Bury College HI+STEM

Courtyard Redesign

BCS-ITR-00-XX-RP-L-0010

June 2022

Bury College - HI+STEM
Courtyard Redesign to
Accommodate Phase 2 Works
BCS-ITR-00-XX-SK-L-0003
22.06.2022

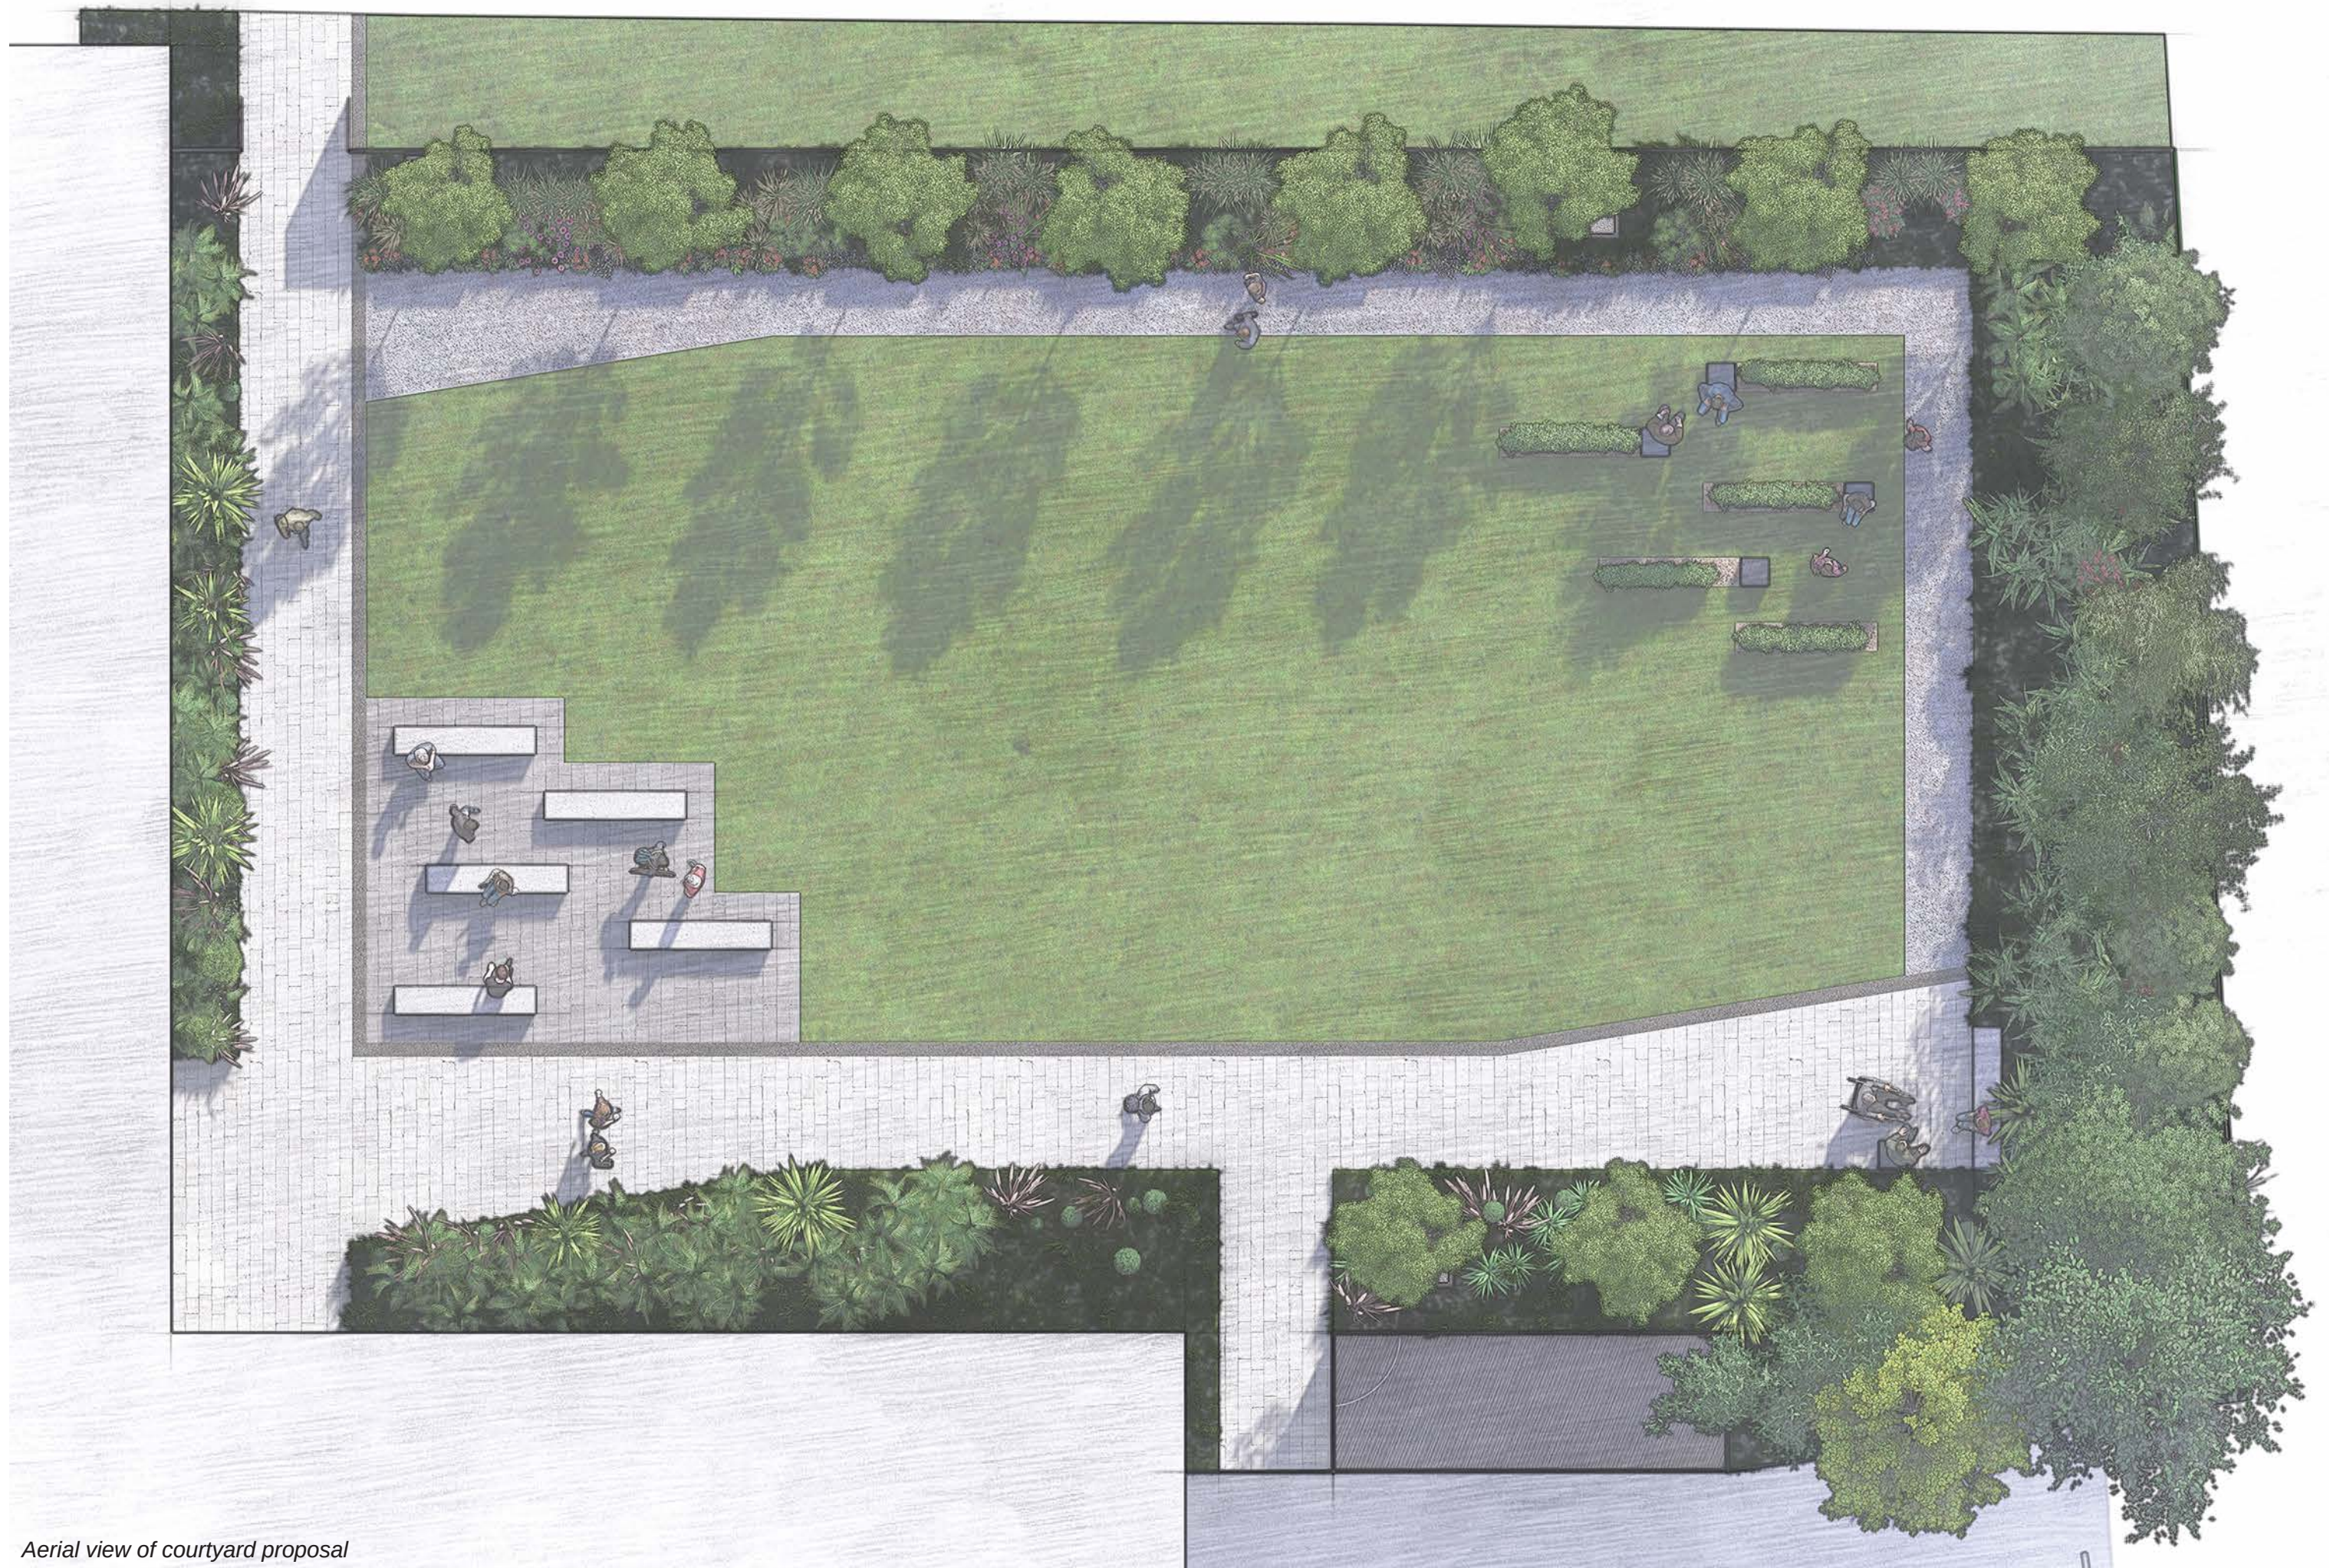
Raised metal edging (aluminium) will still be proposed to the planter at the edge of the proposed building, but has been removed from the planting beds which sit under the footprint of phase 2. These planting areas will incorporate timber edging

Different surfaces have different balance of durability, appearance affordability and potential spread. Loose gravel would be most cost effective but could move around significantly. Self binding would stay in place much better but the top course could still spread onto the adjacent paving and lawn. Resin bound would stay in place and have the best finish, but is more costly

Tree Containers - To Angouleme Way edge and between courtyard and parking area

Specification: Steel (powder coated) or GRP (to be approved)
RAL 7021 Black Grey (or similar approved)

Metal Edging - to courtyard area generally

Fencing Panels - To Angouleme Way and between courtyard and parking area

Generally timber hit & miss panels with timber posts to 2m height
Black

Feature fencing panels to entrance gate to be Cor-ten steel to 2m height

Edging Type E5 - To edge between main access route and lawn / social

Specification: Hardscape Kobra Granite - Bush Hammered
250W x 500L (mm)

Paving Type 2 - To general courtyard access routes

Specification: Tobermore Braemar
70% Alto Silver Ground, 30% Alto Silver Textured
100W v 200L (mm)

Paving Type 3 - To courtyard social area

Specification: Tobermore Braemar
70% Alto Silver Ground, 30% Alto Silver Textured
100W v 200L (mm)

Secondary footpath - To Angouleme Way edge and eastern edge of courtyard

Specification: Self binding gravel (Breedon Wayfarer) or Loose gravel (14mm Dove Grey chippings) or Resin bonded aggregate (Sureset 6mm Norwegian Pearl)

All with 50mm timber edging
